ADDENDUM TO INVITATION TO BID

PROJECT: **BID #D00424 – STAUNTON CROSSING – ELEVATED WATER STORAGE TANK**

DATE: **MAY 9, 2024**

ADDENDUM: **1**

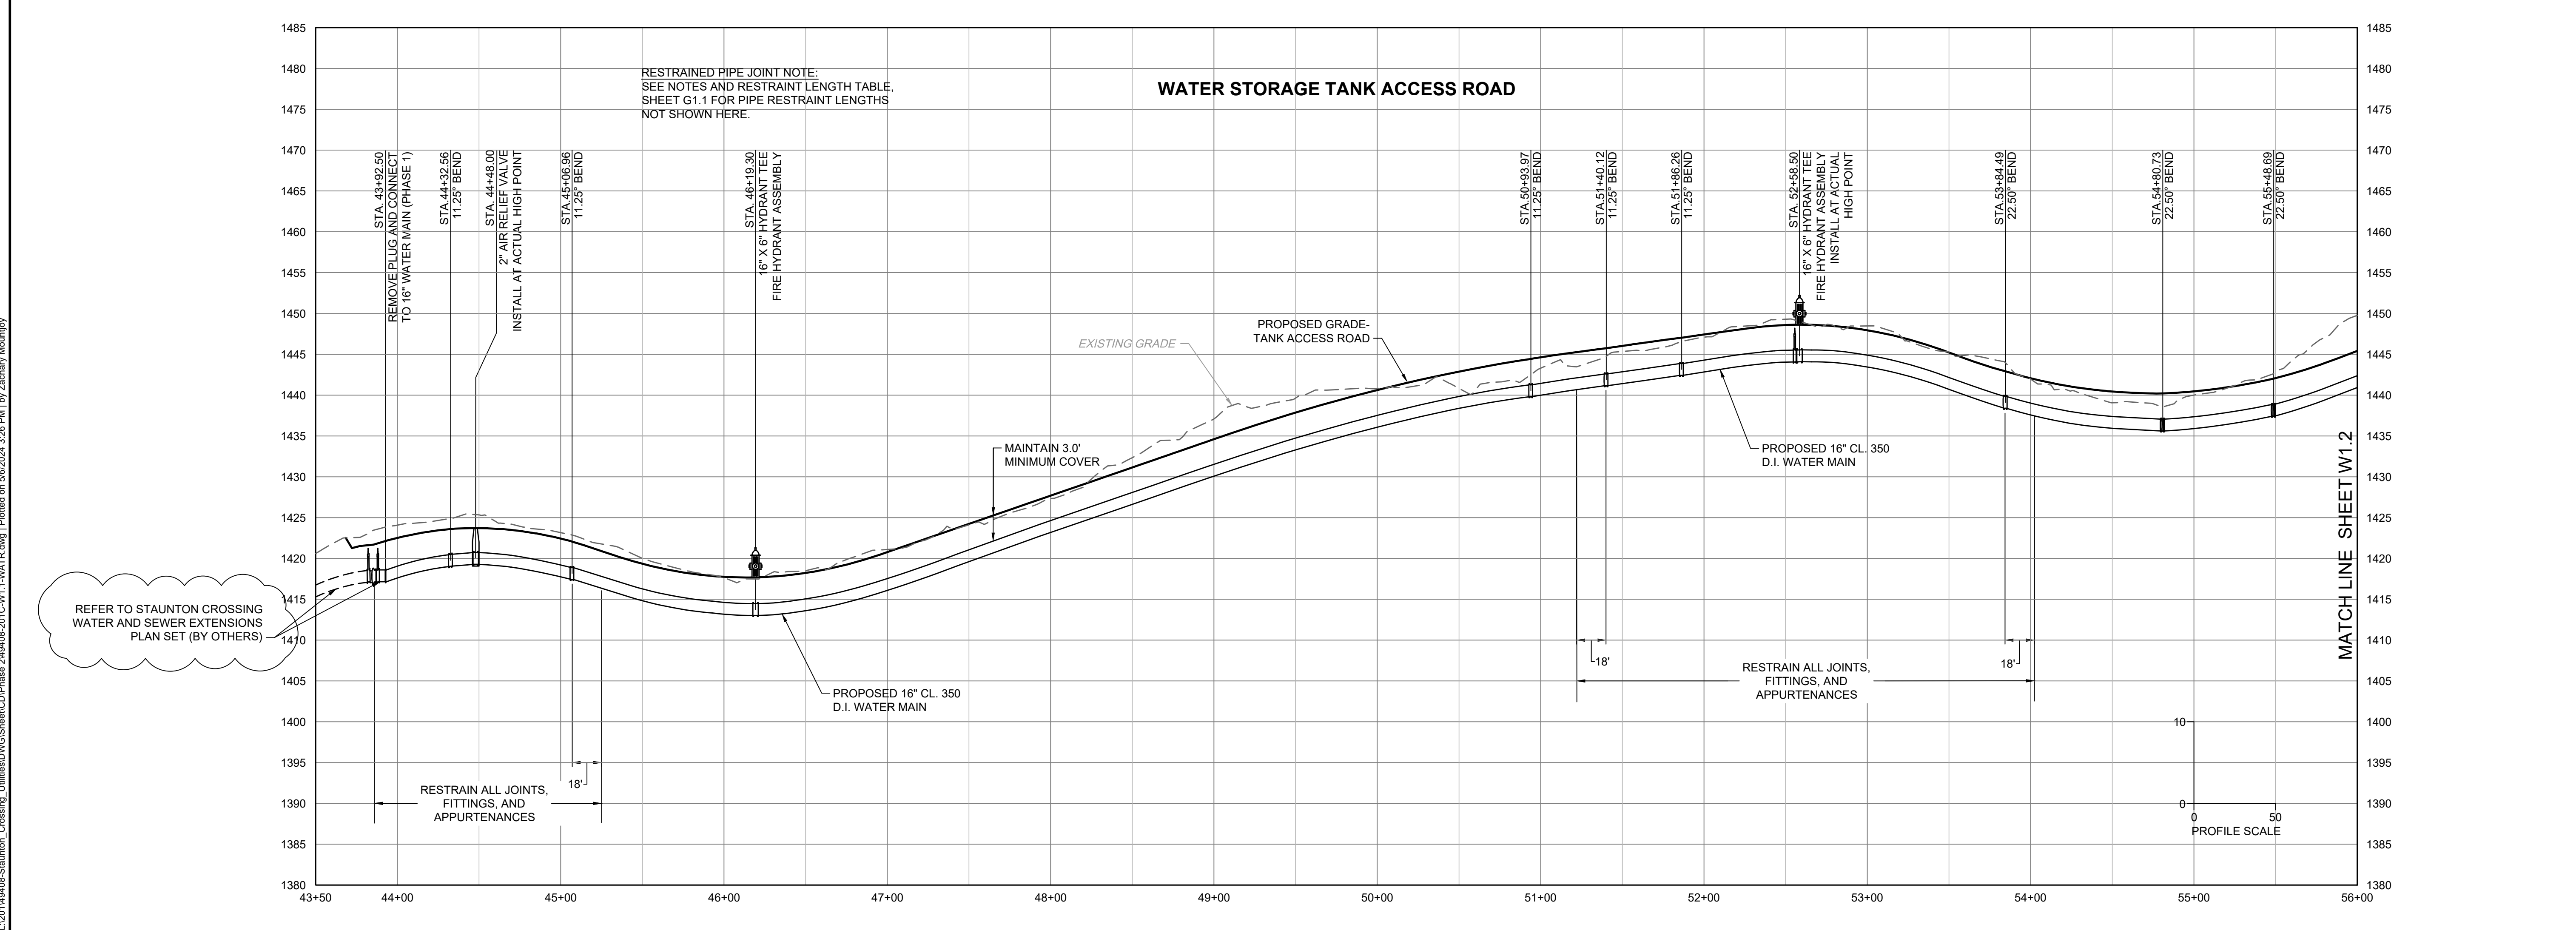
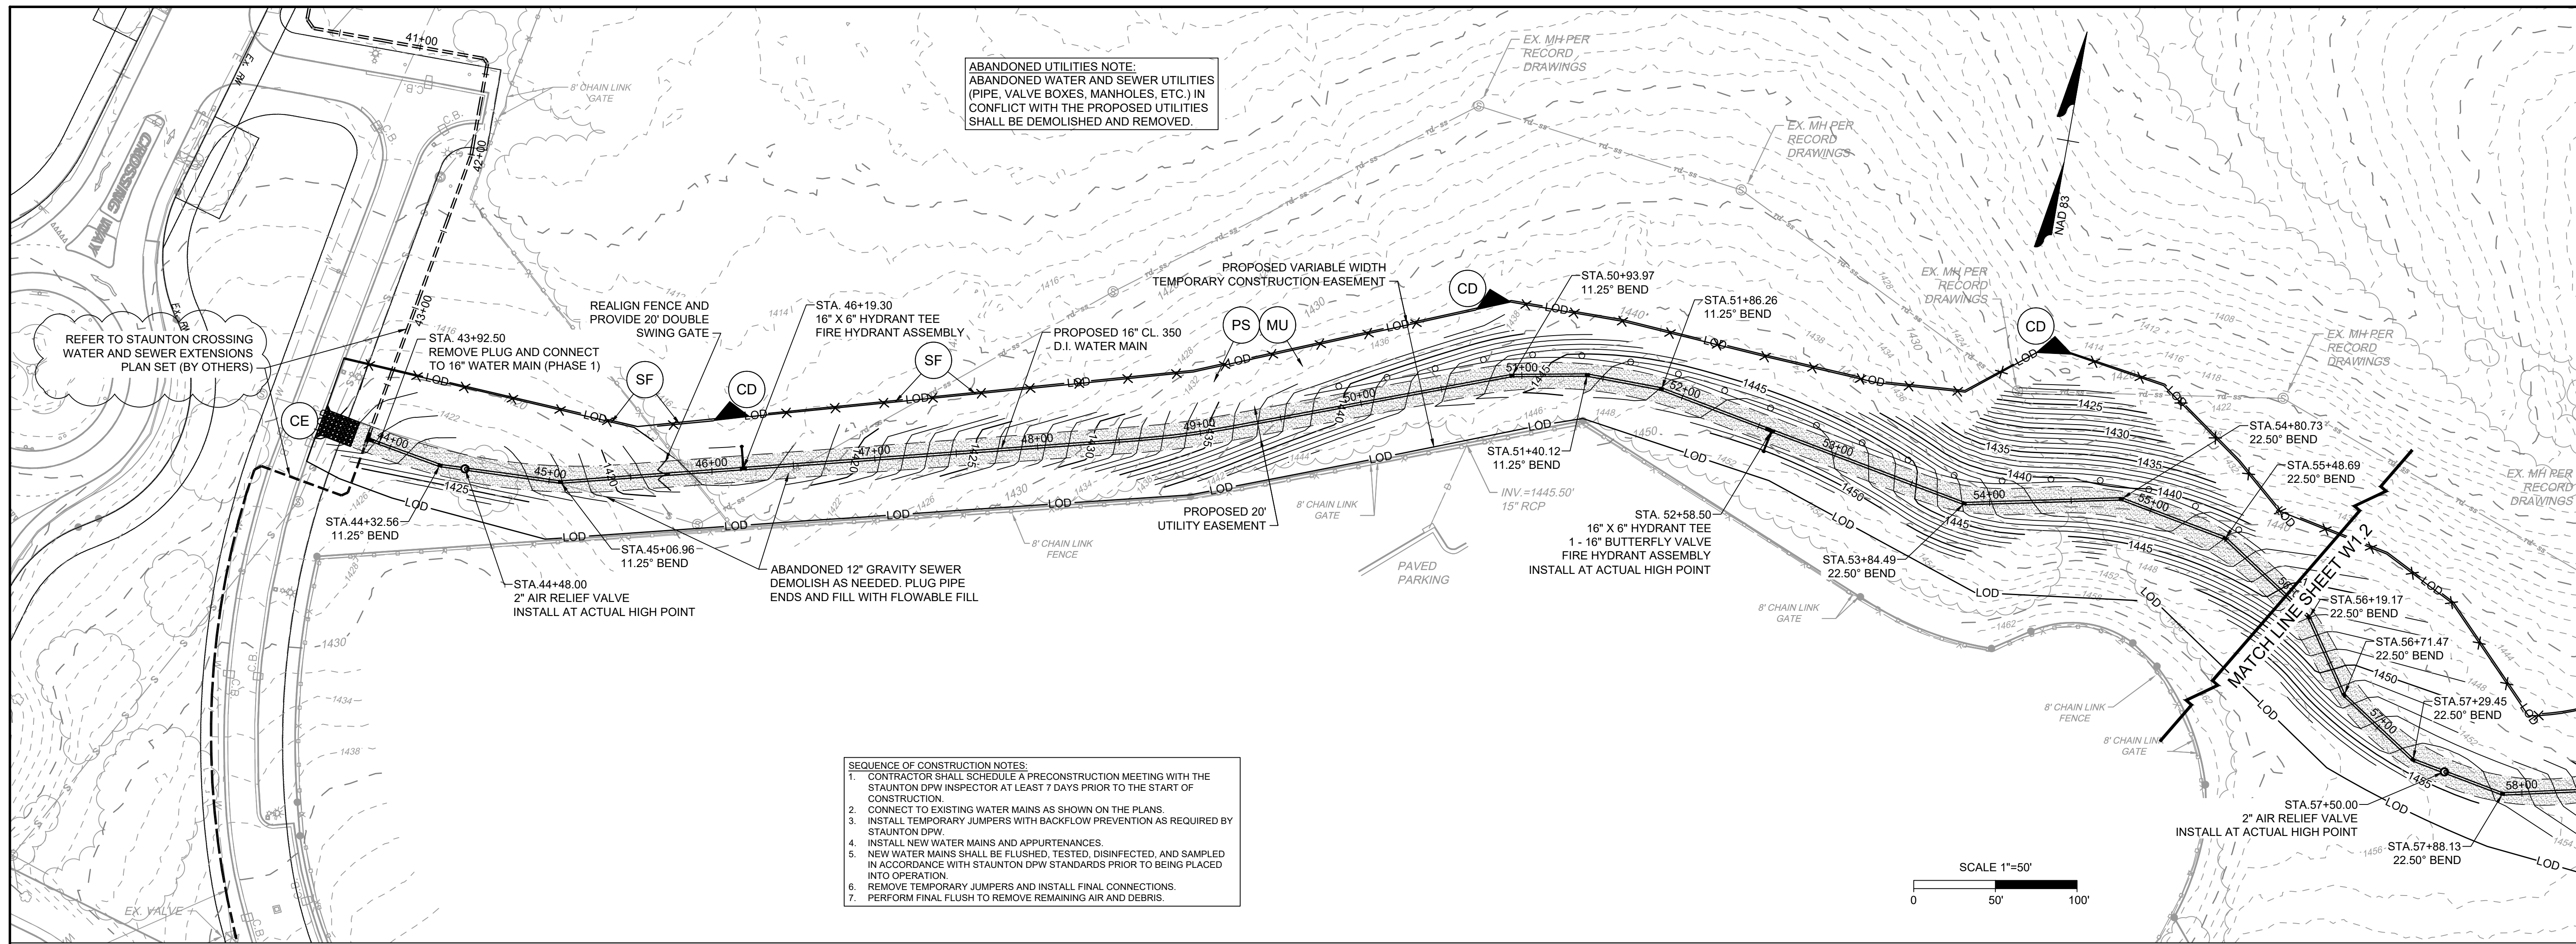
41. Sheet W1.1 – Plan note instructs the Bidder to refer to the Staunton Crossing Utility Improvements – Phase 1 Plan Set. Can this plan set be provided?

Response: Please refer to City of Staunton Bid #D00324 – Staunton Crossing Water and Sewer Extensions project for details regarding the water main connection. References to this project have been revised to refer to the correct project title.
